|  |  | ayan an an an an ang an ang ang ang ang an   |  | RECEN  | /ED T   |  |                                       |  |
|--|--|--|--|--|---|--|---------------------------------------|--|
| F&rm ₹₹60-\$5<br>(August 2007)   | UNITED STATES<br>DEPARTMENT OF THE INTERIOR  |  | DEC 162  | DEC 16 2013  |   | FORM APPROVED<br>OMB NO. 1004-0135<br>Expires: July 31, 2010                 |                                       |  |
| <ul> <li>I. Type of Well</li> <li>Oil Well S Gas Well Other</li> </ul>   |  |  |  |  |   | 8. Well Name and No<br>NORTH SHUGAI  | RT FEDERAL 002                        |  |
| 2. Name of Operator<br>CIMAREX ENERGY CO OF COLORADOMail: DEYLER@MILAGRO-RES.COM   |  |  |  |  |   | 9. API Well No.<br>30-015-31459  | <u> </u>                              |  |

# Permanent Abandonment of Federal Wells Conditions of Approval

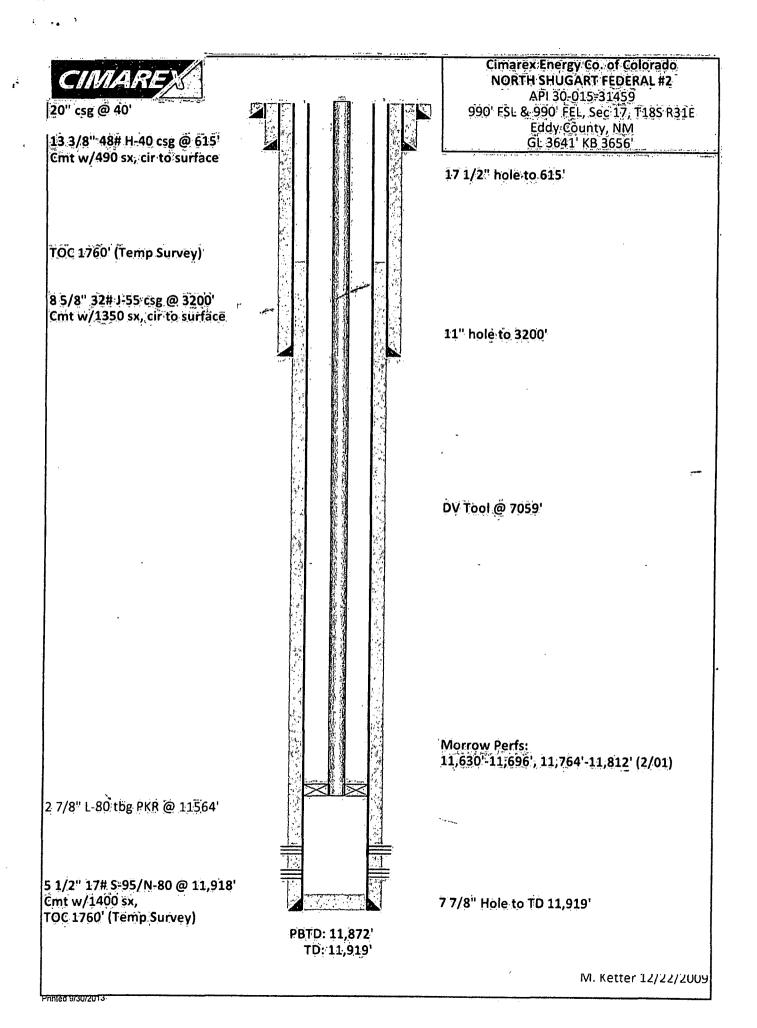
|  |  | ayan an an an an ang an ang ang ang ang an   |  | RECEN  | /ED T   |  |                                       |  |
|--|--|--|--|--|---|--|---------------------------------------|--|
| <ol> <li>4) PUMP 25 SXS.</li> <li>4) PUMP 25 SXS.</li> <li>5) PUMP 25 SXS.</li> <li>6) PUMP 25 SXS.</li> <li>6) PUMP 25 SXS.</li> <li>7) PUMP 25 SXS.</li> <li>8) PUMP 75 SXS.</li> <li>9) PERF. X ATTE</li> <li>10) PERF. X CIRC</li> <li>11) PERF. X CIRC</li> </ol> | P 11,550'; P<br>CMT. @ 10,<br>CMT. @ 9,7<br>CMT. @ 8,7<br>CMT. @ 3,2<br>CMT. @ 3,2<br>CMT. @ 3,2<br>CMT. @ 2,8<br>MPT TO SQ<br>MPT TO SQ<br>. TO SURF.<br>JT OFF WEI   | UMP 30 SXS.CMT. @ 11<br>700'-10,400'(T/MRW.,T<br>'95'-9,605'(T.CANY.).<br>'90'-8,610'(T/WC.); WOC<br>44'-6,974'(DV TOOL).<br>'00-4,850'(SPACER). 52<br>'65'-3,135'(8-5/8"CSG.SH<br>(65'-2,300'(T/S.A., T/GRB<br>Z. 120 SXS.CMT. @ 1,10<br>QZ. 40 SXS.CMT. @ 665'<br>FILLING ALL ANNULI, 1<br>LHEAD 3' B.G.L.; VERIF<br>Code Macked<br>For CIMAREX ENER<br>Committed to AFMSS for p | X TAG CM<br><b>3 44 - 5</b><br>10E); WOC<br>G.)<br>10'-750'(T/)<br>-565'(13-3/<br>100 SXS.C<br>Y CMT. T(<br> | IT. PLUG.<br>CB1 JB2<br>X TAG CMT. PLU<br>(ATES,B/SALT); W<br>8"CSG.SHOE); WG<br>MT. @ 300'-3'(T/S/<br>D SURF. ON ALL A<br>CSCCC<br>ied by the BLM Wel<br>COLORADO, sent | G.<br>G.<br>JOC X TAG.<br>DC X TAG.<br>ALT).<br>NNULI; WE | SEE ATTAC<br>SEE ATTAC<br>CONDITION<br>ELD ON STEEL PLA<br>ACC<br>ACC<br>ACC | ATTACHED<br>CHED FOR<br>VS OF APPROVA |  |

CSGS. X INSTALL DRY HOLE MARKER.
